### City of Mississauga Department Comments

Date Finalized: 2022-05-04 File(s): A10.22

**Property Address:** 1333 Queen Victoria Avenue

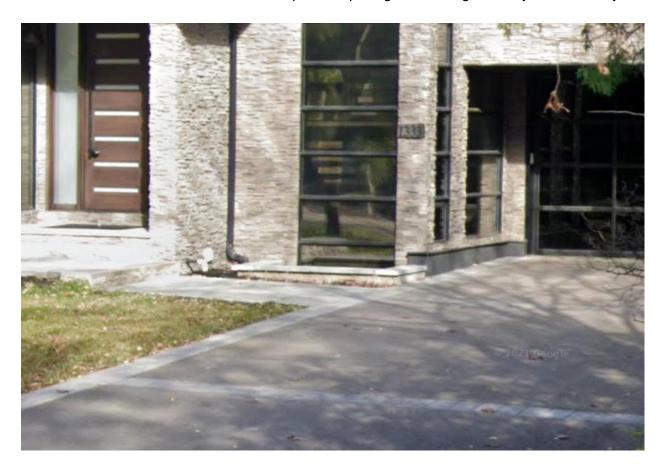
The applicant is requesting a variance to permit a walkway width of 2.5m (8.2ft) attached to the driveway where a maximum walkway width of 1.5m (4.9ft) is permitted. The intent of this portion of the bylaw is to provide a convenient surface for pedestrians (not vehicles) and assists in

defining an entryway to a dwelling. While the walkway attachment appears to be excessive, based off its design, staff are of the opinion that it will not accommodate vehicular access or parking. Furthermore, the walkway appropriately defines the entryway to the dwelling.
